Fiat Auto S.p.A.

**Panda**

### 1810 A 201 MA CLUTCH DRIVEN DISC

### CLUTCH ASSEMBLY

A. Nut  
B. Lock nut

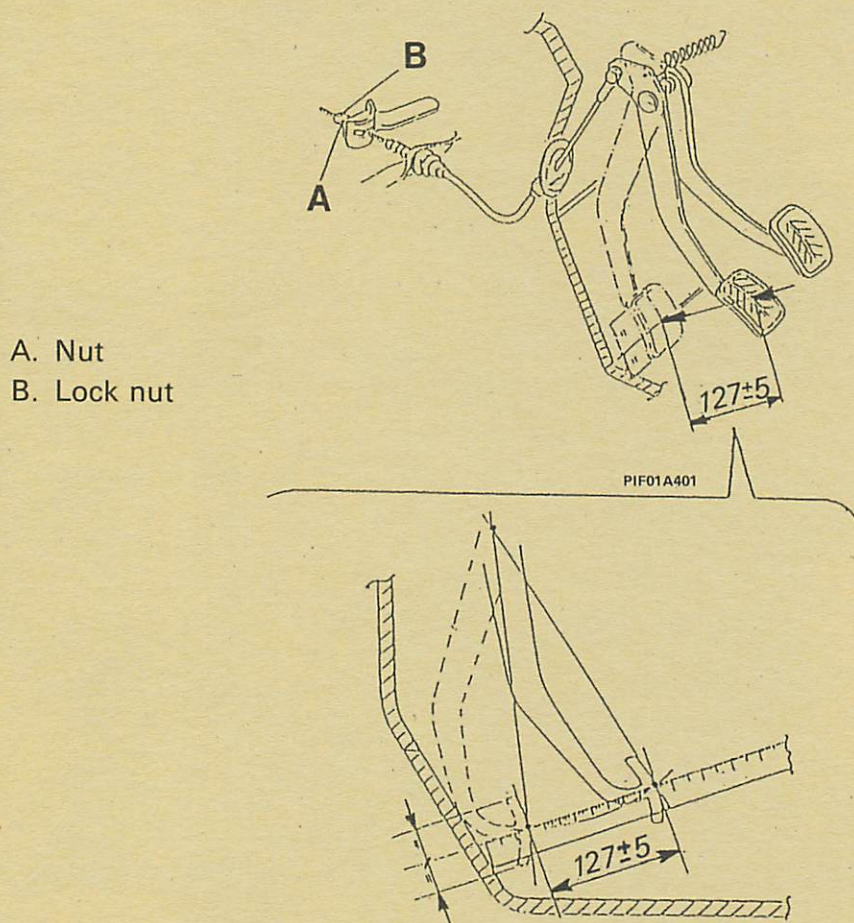
Clutch noisy/difficulties in engaging gears with pedal fully depressed on account of interference between the spring and the driven disc.

- Make sure that there are no obstacles which restrict the total travel of the clutch pedal (remind the Customer to avoid using extra mats under the pedals).
- Let the clutch release bed in by fully depressing the pedal 3 or 4 times.
- Check that the travel of the clutch pedal between the rest position and the end of travel position (see diagram) is equal to  $127 \pm 5$  mm.

- Working on nut A and lock nut B take care to prevent the rotation of the cable during the adjustment operation.

**NOTE** *If after having carried out the operations described above the problem has not been solved, replace the clutch assembly with one ordered from the Parts Division no. 5892499 (supplier Valeo).*
